Addendum

ClientTransport for NSWDate24 March 2016Prepared byBen IsonProject No.IA088400.105

Project Hornsby Junction Remodelling and Commuter Car Park

Figure 3: Operational multi-storey car park noise model (looking north along George Street)

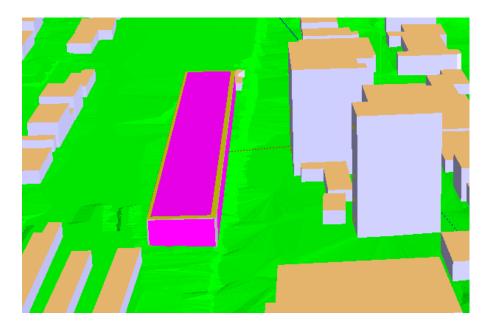
The movement of vehicles around the car park would occur at greater elevation compared to the REF car park design. The modelling has been updated for the modified design (Figure 3) to predict sound power levels (SWL) for an operator unlocking, entering and starting a light vehicle, followed by acceleration out of a car park.

Table 3 presents the likely L_{Aeq} noise levels for these cars operating within the modified multi-storey car park for the nearest residential receivers.

These results show that noise levels are expected to comply with the operational Industrial Noise Policy (INP) noise criteria at most nearby locations during peak usage (worst case scenario). It is

possible that under these conditions, noise levels at the upper floors of the George Street units may marginally exceed INP criteria. Although this assessment considers a worst case noise level, which may last for only peak hour periods of the day, it is important that transmission paths between internal areas of the car park and the higher levels of the Avanti units are considered during detailed design.

As per the previous assessment, this noise modelling does not consider the use of polished concrete, and is recommended that this surface is not used in the facility.
